DEPARTMENT OF PLANNING & INFRASTRUCTURE

SUBJECT: MODIFICATION TO THE UTS FACULTY OF SCIENCE BUILDING AT THOMAS STREET, UTS CITY CAMPUS (MP 09 0213 MOD 1)

To determine a modification request (MP 09_0213 MOD 1) for the UTS Faculty of Science Building project approval, which seeks to make minor design changes to the rooftop layout, internal configurations, façade and height of the plant.

Figure 2: Proposed Northern Elevation (Thomas Street)

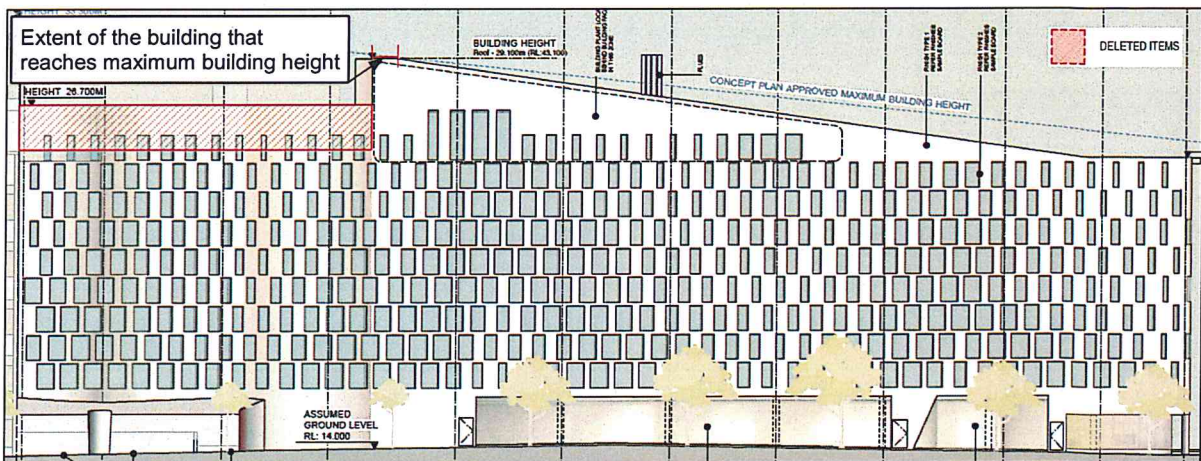
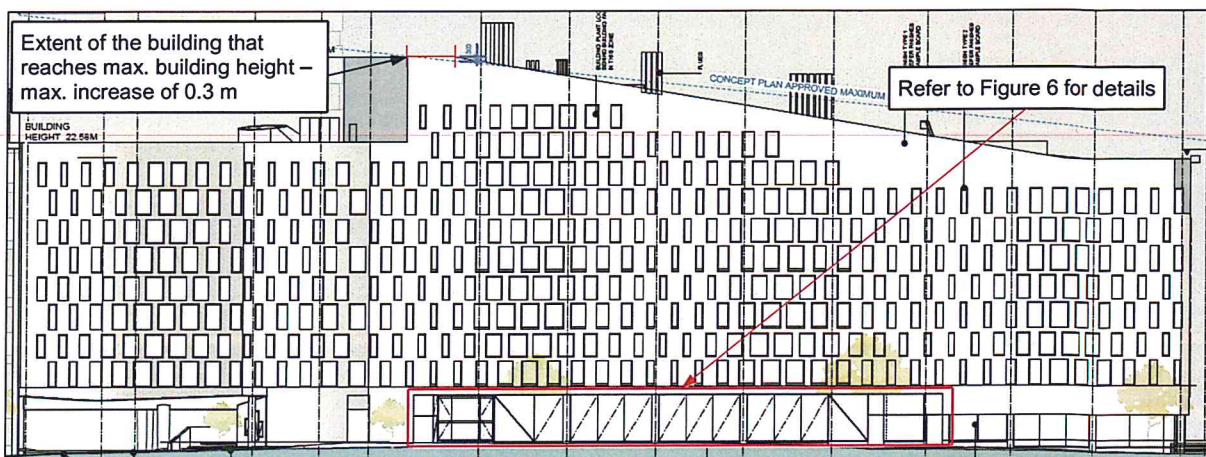
The adjustments to the slant of the roof to accommodate lift shafts and service risers results in a marginal height increase by 0.3 metre in one section of the roof to match the maximum building height (see **Figure 1** and **2**).

- the height increase at its greatest is minor (0.3 metres) and only affects a relatively small portion of the building and the maximum building height remains unchanged;
- the general shape of the roof and slant is maintained, which continues to provide visual interest; and
- solar access to the internal open space area (Alumni Green) would be largely unaffected by the changes to the height and the minimal impacts would be adequately offset by the improved solar access outcomes resulting from the deletion of the eastern portion of Level 5.

Figure 5: Proposed Southern Elevation

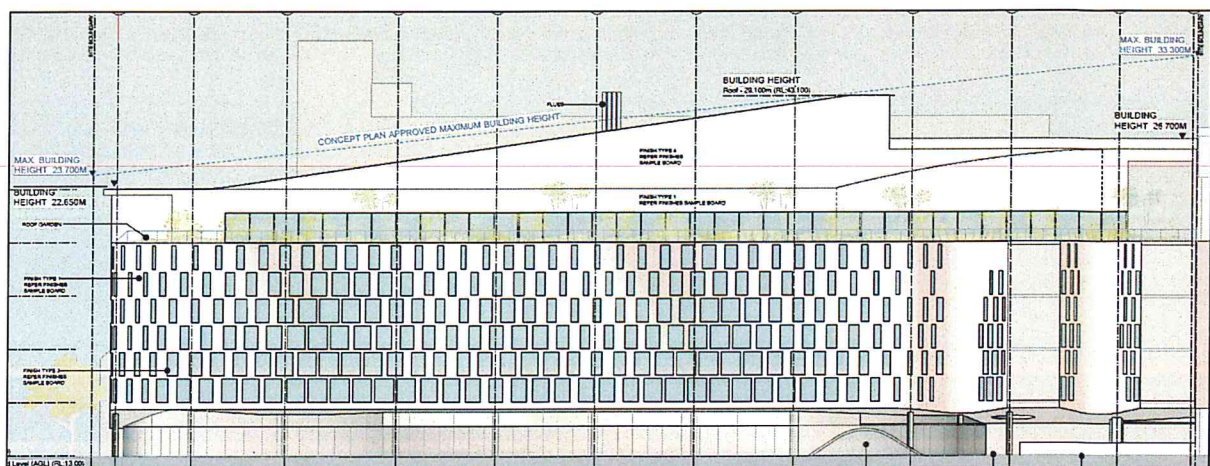
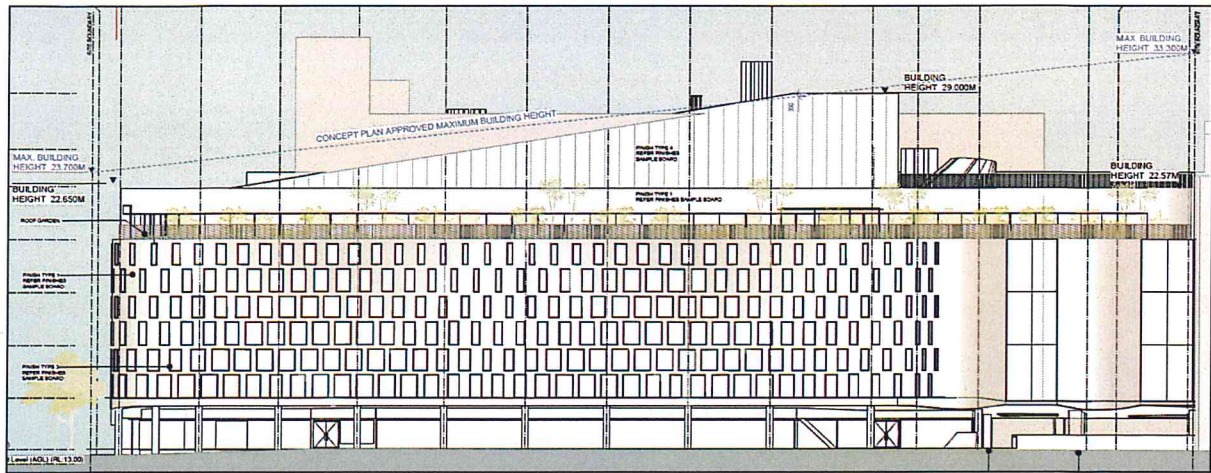
The proposed changes to the façade, including removal of glazing elements and provision of safety screening on Level 4, would change the appearance of the building (see **Figures 3 to 5**).

The deletion of the windows is confined to the eastern portion of the southern elevation where the façade is curved with two recessed columns. The department considers the changes would not have an adverse impact as the building maintains the curved form along the eastern section, which was one of the key elements of the winning scheme of the design competition for the Thomas Street Building. Whilst the windows have been deleted in this eastern portion, the windows are south-east and south-west facing and therefore would have minimal value in providing solar access to the new building given the narrowness of the recesses and the shadows cast by the building itself. Solar access would be maintained via the north facing windows to this area and the central void on the eastern edge of the building. The department considers that the provision of the safety screening on Level 4 does not adversely impact the design of the building and does not add to the bulk of the building and therefore can be supported.

Figure 6: Part Ground Level Elevation Details (Thomas Street)

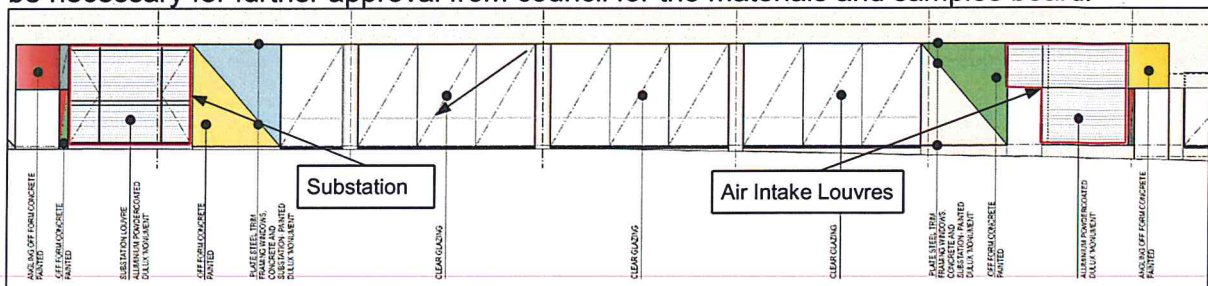
Council have requested that a materials and finishes board be submitted for approval, especially given details for the treatment of the substation along Thomas Street have not been provided. The proponent has indicated that the substation portion of the façade would have a louvred façade which would be integrated into the façade design and complement the air intake louvres at the western end of the Thomas Street elevation (see ground floor detailed design in **Figure 6**). Whilst the design controls prescribed in the concept plan sought to provide further activation at ground level, the department considers the location of the substation acceptable and the design of the façade acceptable. As the remainder of the approved materials and finishes are unchanged, the department considers that it would not be necessary for further approval from council for the materials and samples board.
